ROYAL ARCADE
BOSCOMBE

PROPOSED ROOF
PLAN

Sheet Title
**EXISTING &
PROPOSED NORTH
ELEVATION**

Sheet Title
PROPOSED SOUTH & EAST WINGS ELEVATION

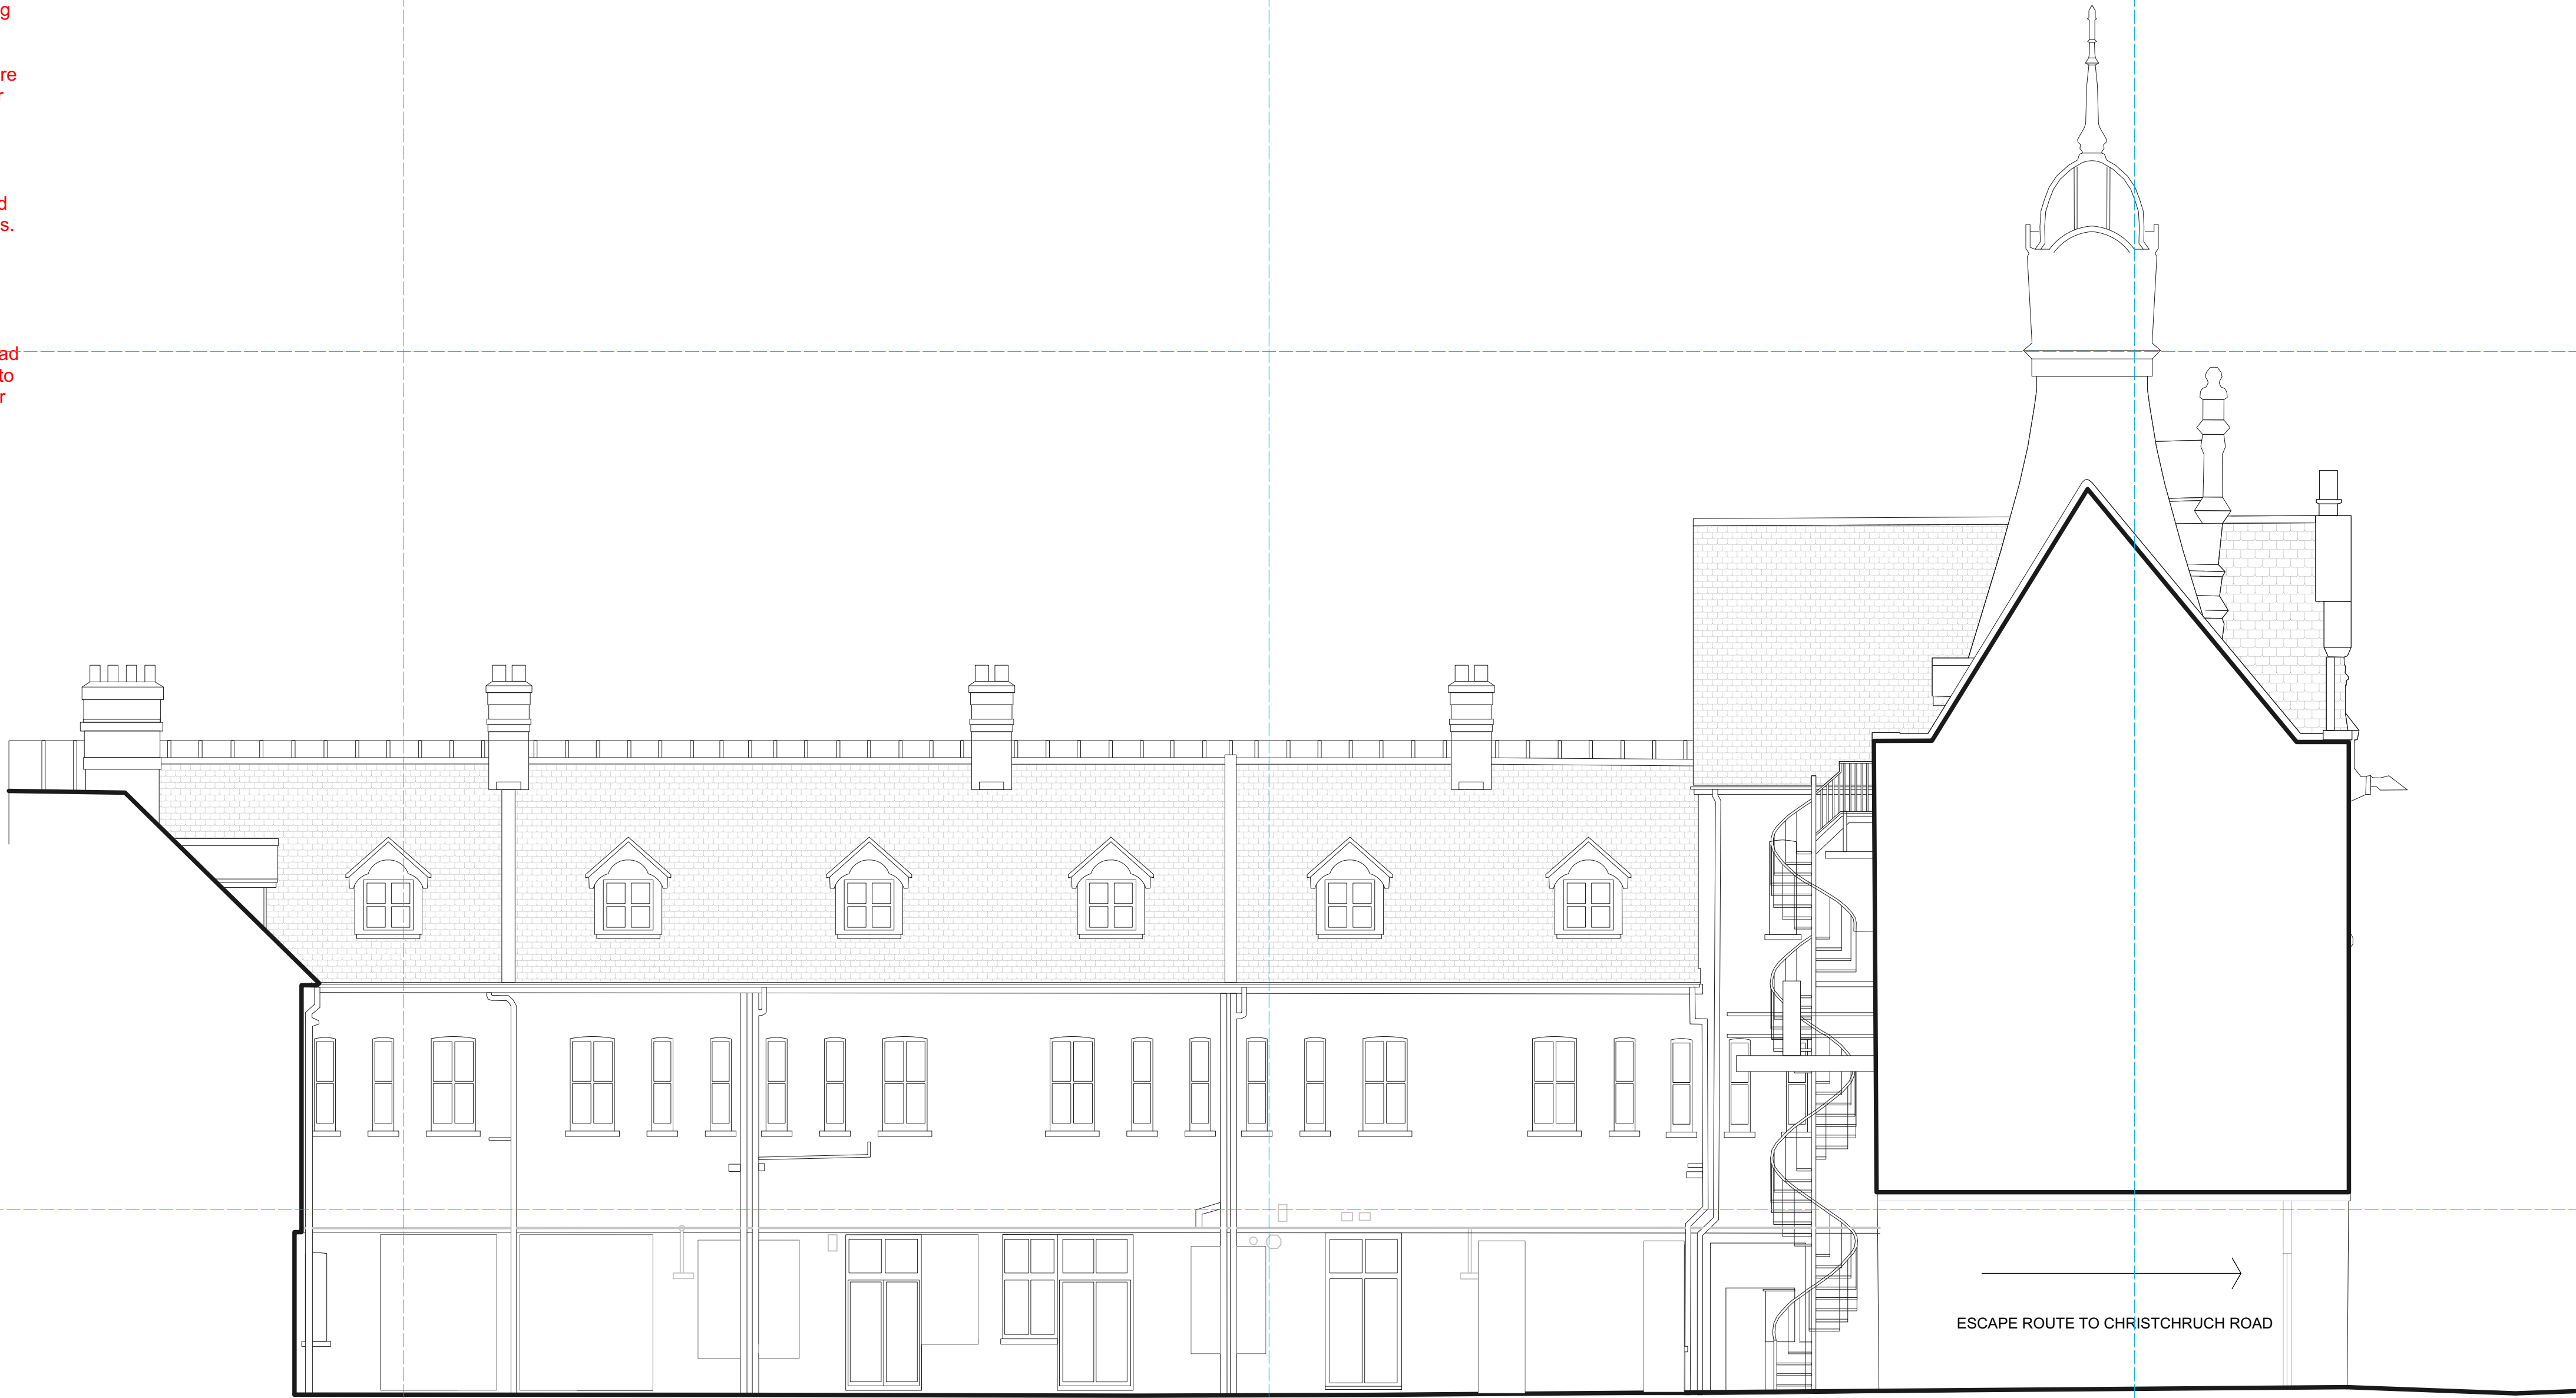
Note:
Bricks and boards must be removed from windows and doors to assess their condition, distinguishing between those that can be restored and those that require reinstatement. Careful examination will determine the extent of repairs needed to revive functionality and aesthetics.

C.	27.02.24	Proposed window & door openings aligned to GF plan
B.	16.02.24	Technical notes added, M&E units moved/size updated, M&E vents updated on roof
A.	04.01.24	Remove solar panels from South and West wings
